UNITED STATES DEPARTMENT OF COMMERCE  
National Oceanic and Atmospheric Administration  
NATIONAL OCEAN SERVICE- Office of Coast Survey  
Hydrographic Surveys Division: Atlantic Hydro Branch  
Norfolk, Virginia 23510

SUBJECT: Review of Hydrographic Survey W00158

Survey Registry Number:	W00158
Survey Location:	American Samoa, Banktop and Slope Environments around Tutalia
Survey Project Number:	OSD-AHB-09
Field Unit:	NOAA Ship <i>Hi'ialakai</i> and NOAA R/V <i>Ahi</i>
Survey Year:	2006
DST Team Member:	Leonard Tyson
SAR Reviewer:	Casie Carrott / <a href="#">PS Eggleston</a>
SAR Reviewer 2:	<a href="#">Gene Parker</a>

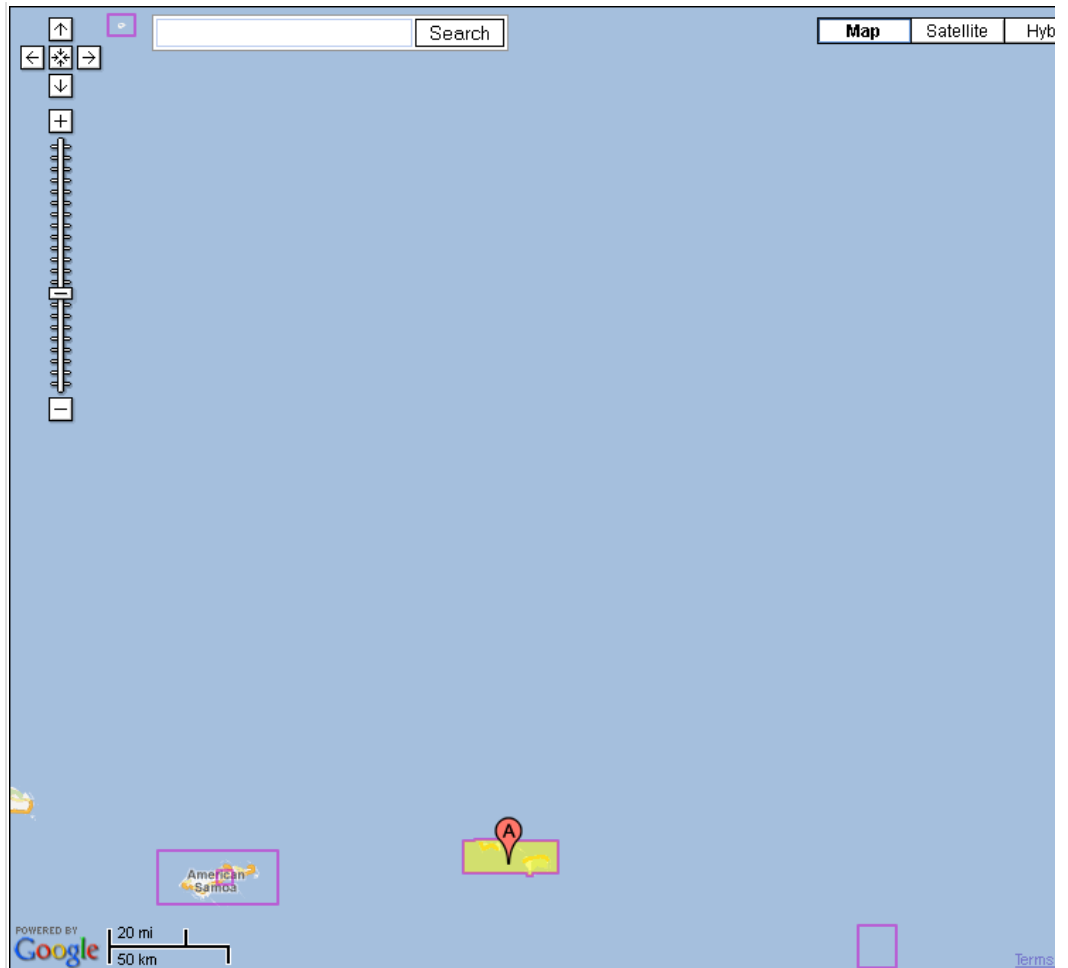
The following lines were isolated from the other HDCS data, because they did not fall within a currently charted area:

The lines that fall in areas that there is currently no chart for were used to create BASE surfaces for submission to NGDC, but are not recommended for use during compilation (see note in Additional Notes section).

The following images illustrate how the above mentioned lines fall outside of the charted areas:

NOAA/NDS/CO-OPS  
 Verified Water Level vs. Predicted Plot  
 1770000 Pago Pago, AM  
 from 2006/02/11 - 2006/03/08

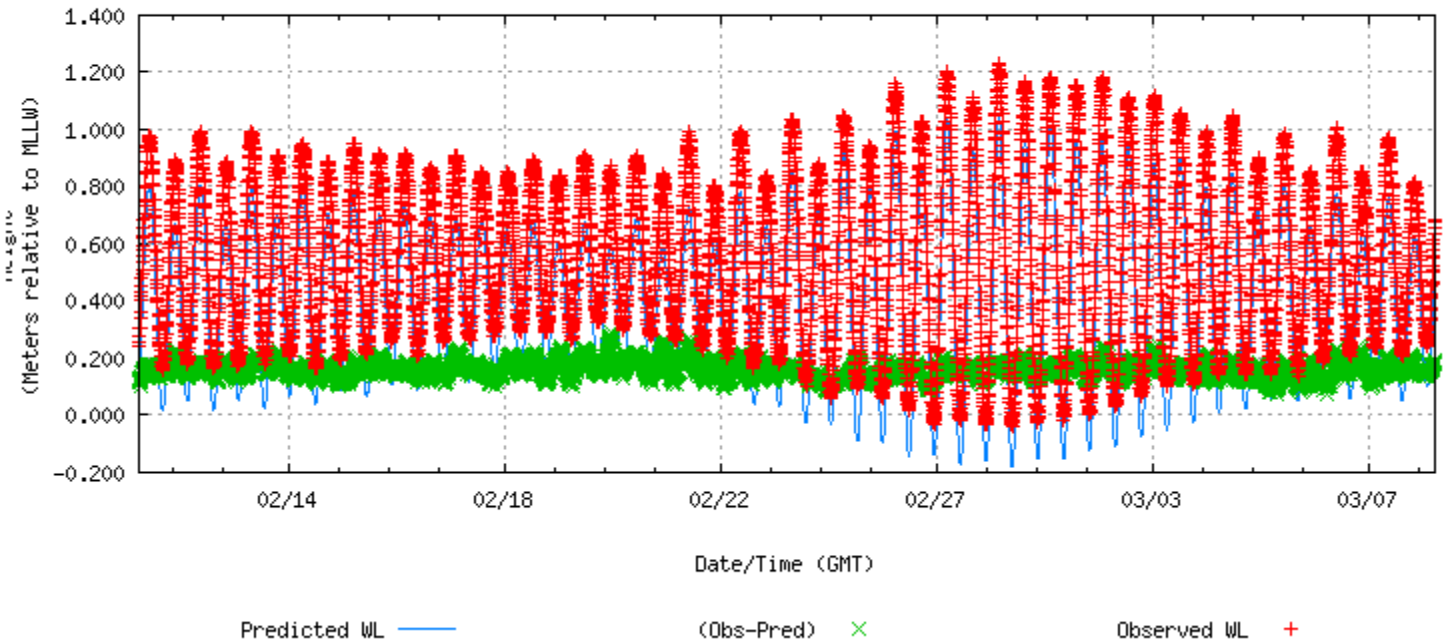
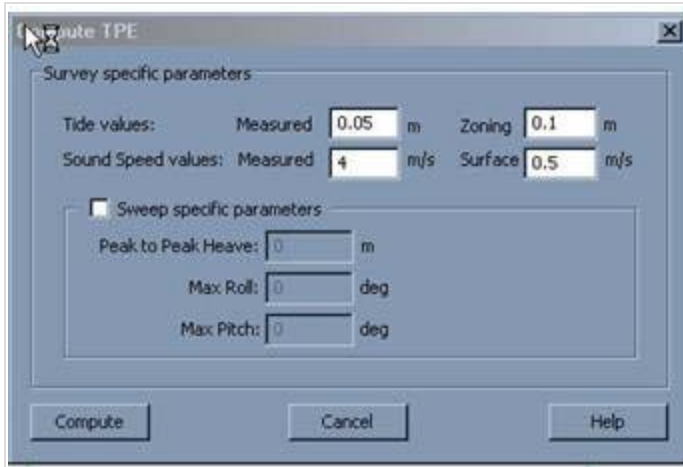
Observed Tides were applied rather than Verified.  
Tide values were applied in real time, and there is no documentation with the survey to indicate what tide gauge was used for this survey.

Based on a review of listed tide gauges on the tides and currents website, a general tide range and predicted vs. observed comparison was reviewed based on the Pago Pago station. For Pago Pago the full tide range is less than a meter, and for the dates of the survey variation between predicted and verified tides was within approximately 0.2m.

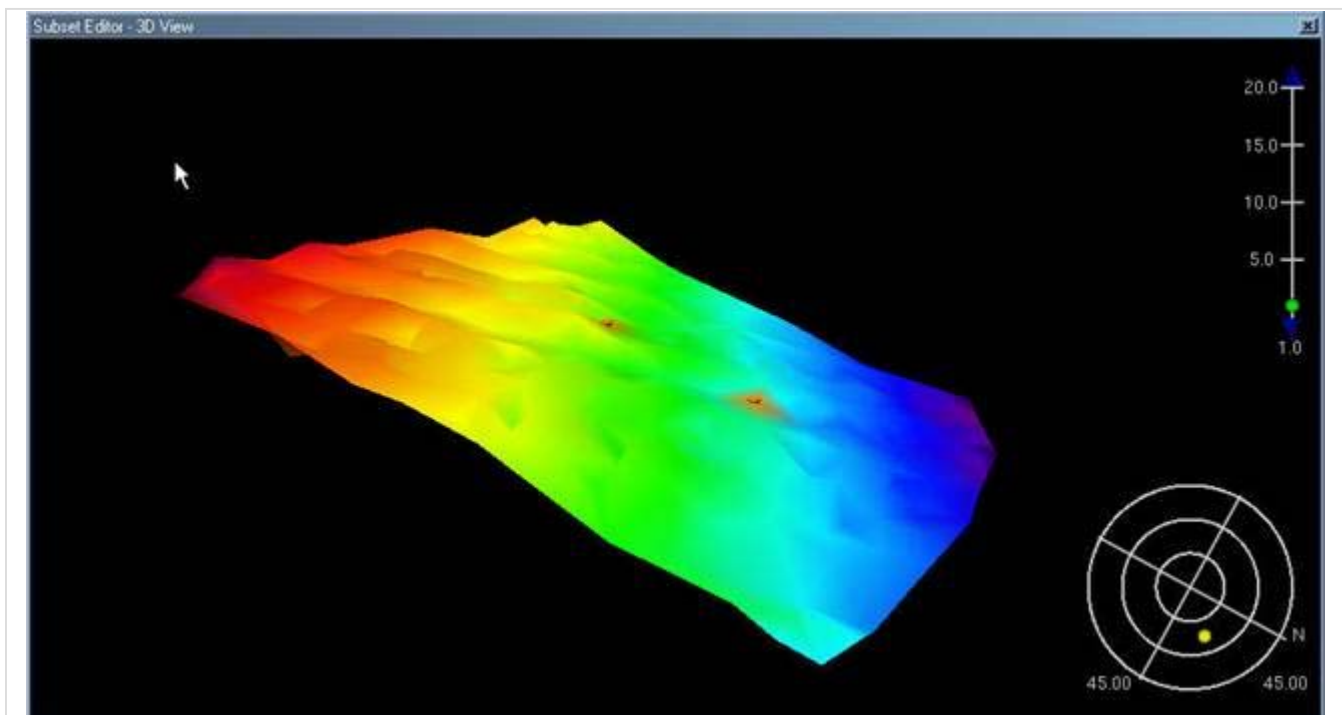
The above are two of three designated soundings assigned by the field, which least depths are 1042 and 1029 meters(left to right).

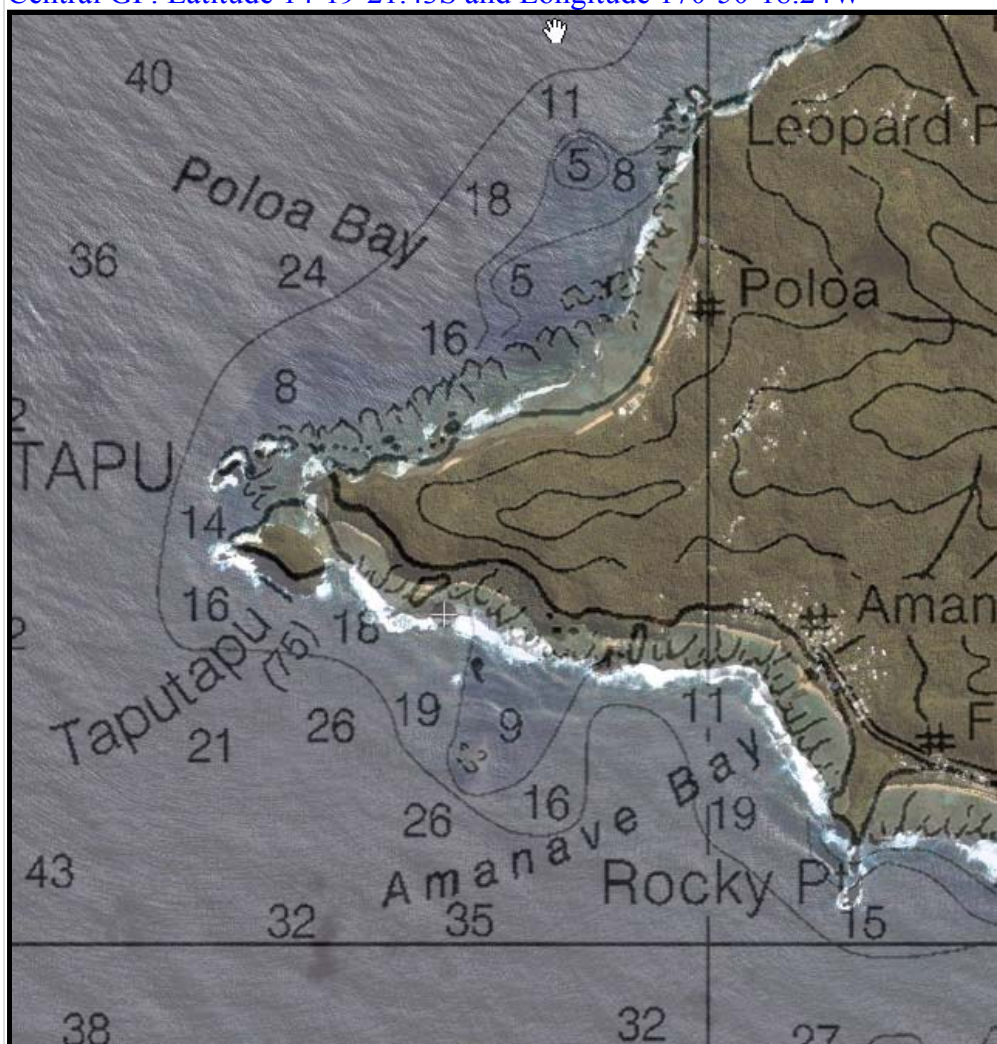
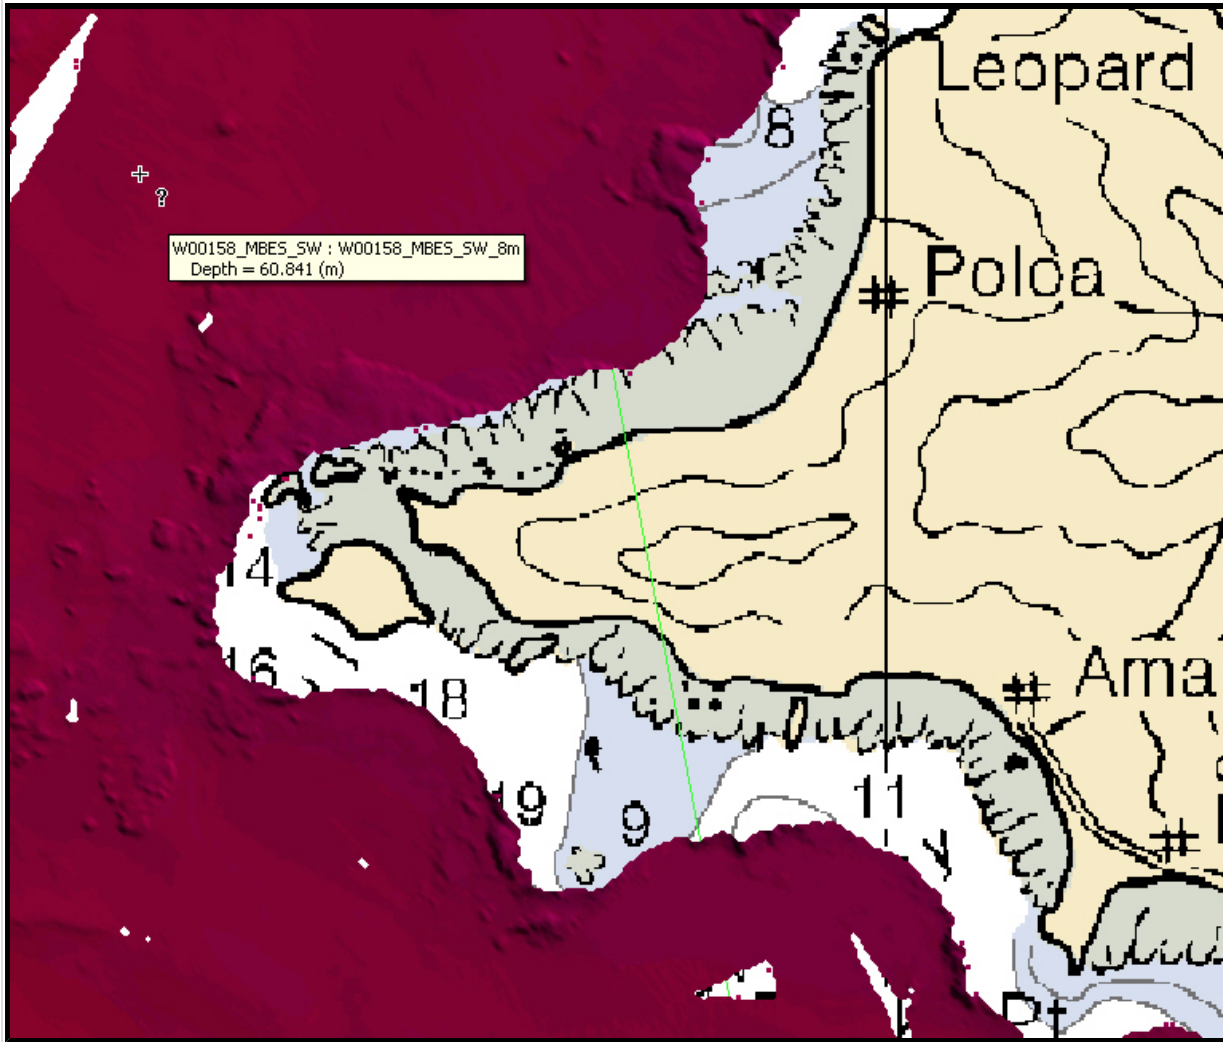
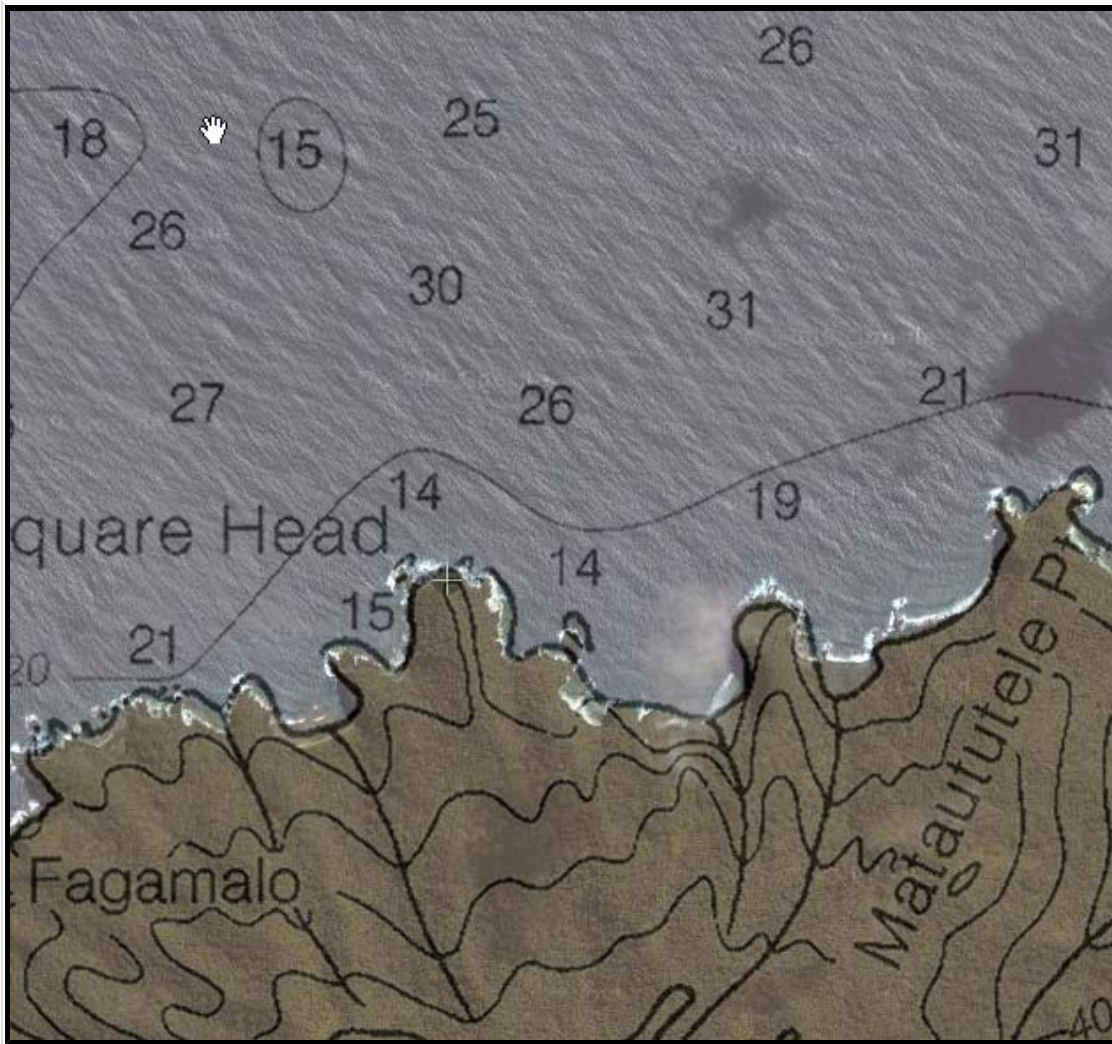
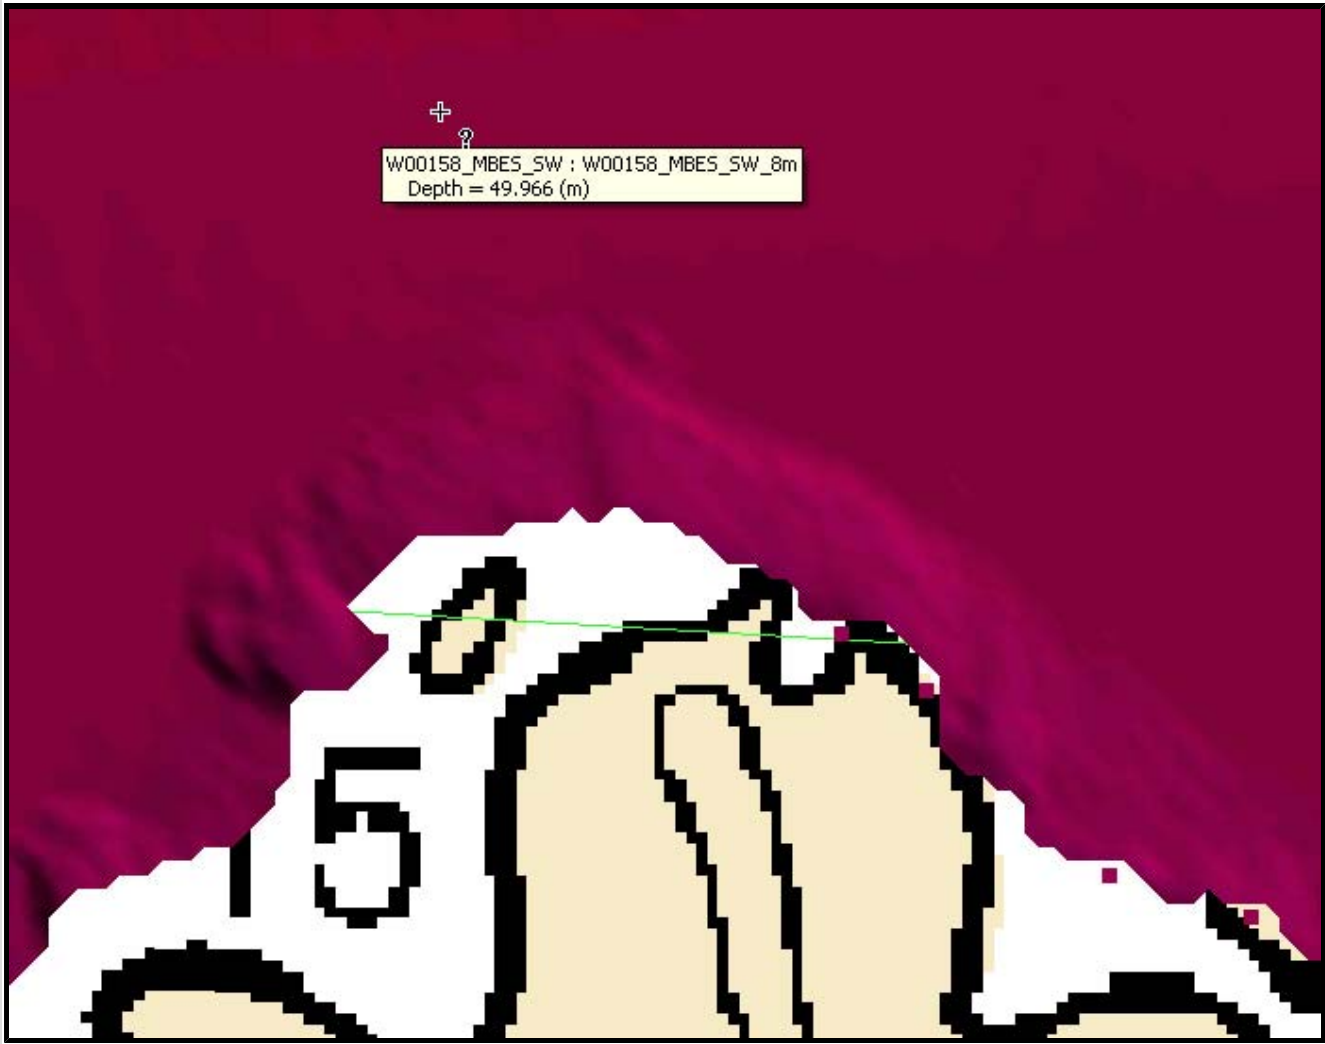
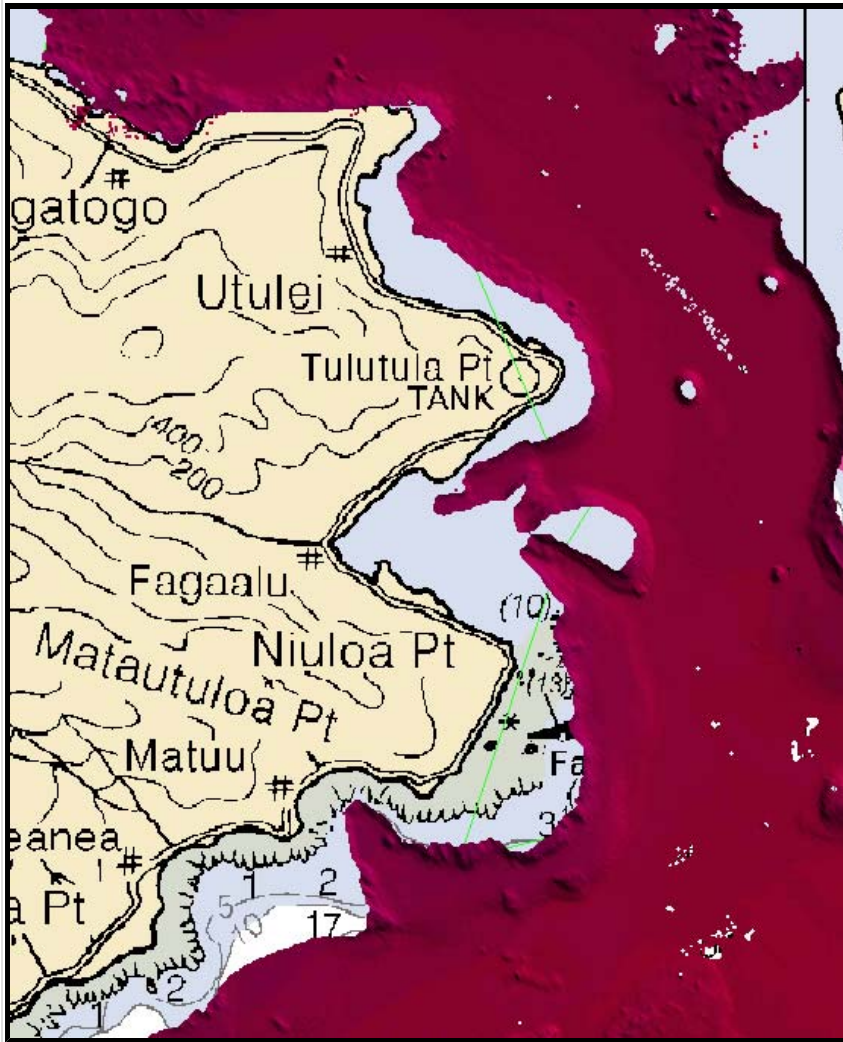
The following images from HIPS data and imagery from NOAA GeoGarage, represent areas where ship track lines run over charted land. However, the GeoGarage images depict that the chart is correctly charted.
